Contract Number: 227-2014

Project Description: Replacement Senior Citizen Center Construction

**LEXINGTON-FAYETTE URBAN COUNTY
GOVERNMENT CONTRACT CHANGE ORDER**
Page 1 of 2

CHANGE ORDER NO. 40

SKA-126

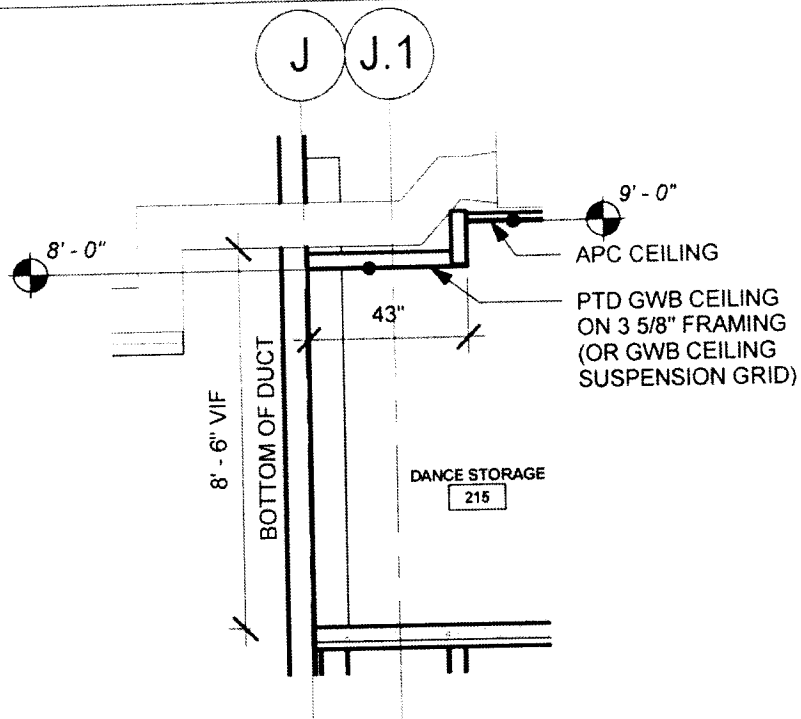
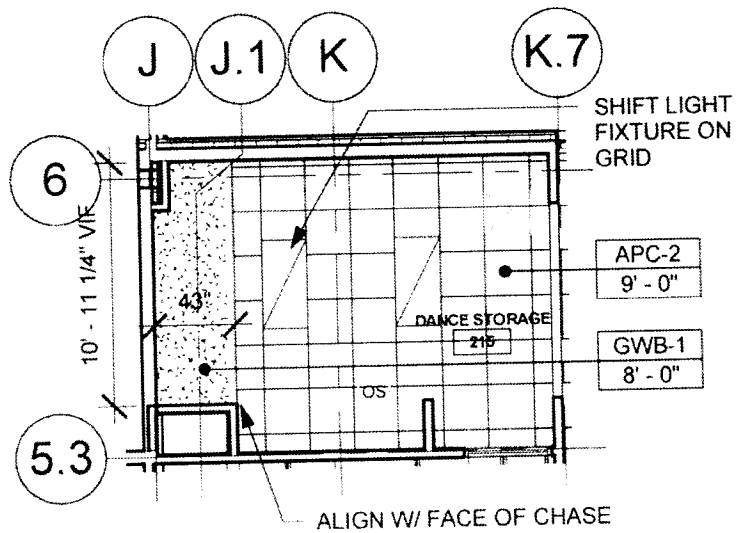
1. Necessity for change: Designed ceiling height conflicts with HVAC ductwork in Dance Storage. Adding a soffit will conceal the ductwork. Flooring installer recommended adding the passive air grilles and underlayment to increase air circulation under the floor and to protect the wood flooring. Plywood is more resilient than drywall and is more appropriate for an exterior storage space.

To avoid conflict with HVAC ductwork, please furnish a painted GWB soffit per the attached sketch. Please verify all dimensions prior to fabrication.

CA-FLOOR GRILLES AT PLATFORM

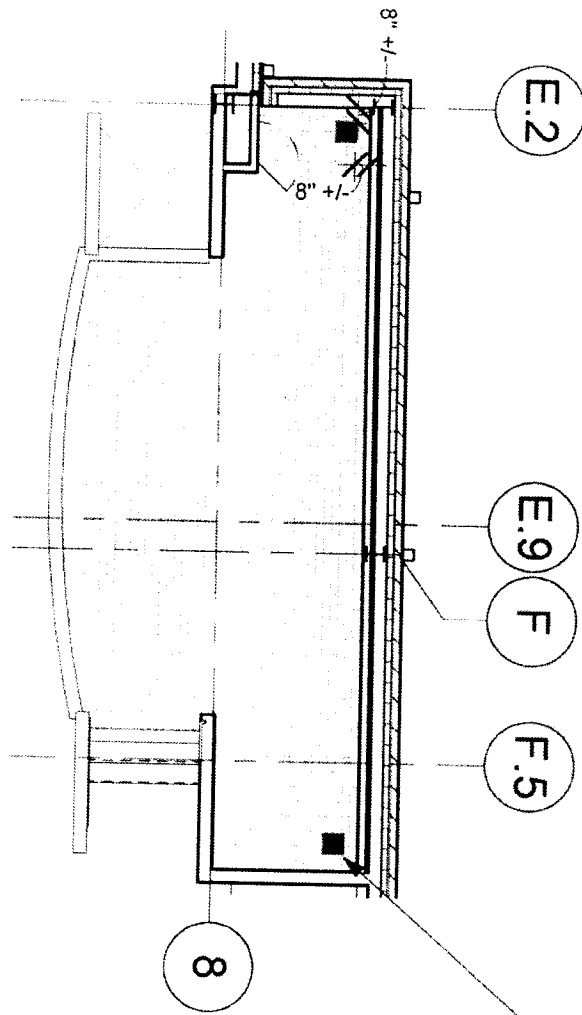
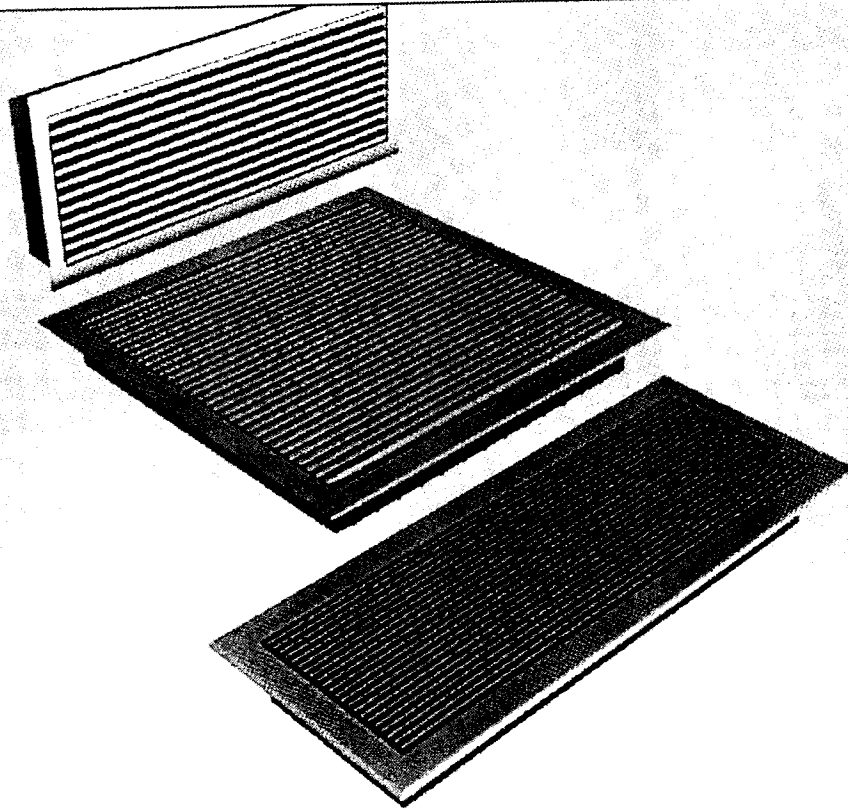
- Per recommendation from the flooring subcontractor, please furnish and install the following improvements for the platform flooring:
- Lay 20 mil minimum plastic nonwoven membrane sheet at the floor slab to inhibit moisture infiltration into the plenum
 - Install (2) displacement floor grilles as shown on the attached sketch for adequate air movement in the plenum. See basis-of-design product data in attached documents. Install blocking as required to adequately support floor grilles for normal traffic. Install between floor support studs; do not cut floor support studs to install (dimensions on the attached sketch are suggestions; locate as near

to this dimension without cutting studs).

DISPLACEMENT FLOOR GRILLE, TYP
 -INSTALL PER MANUFACTURER'S
 INSTRUCTIONS
 -WOOD BLOCKING AS REQUIRED TO
 MATCH ROUGH OPENING BETWEEN
 FLOOR SUPPORTS
 -FIN LAYOUT AND FINISH PER SPEC
 SHEET
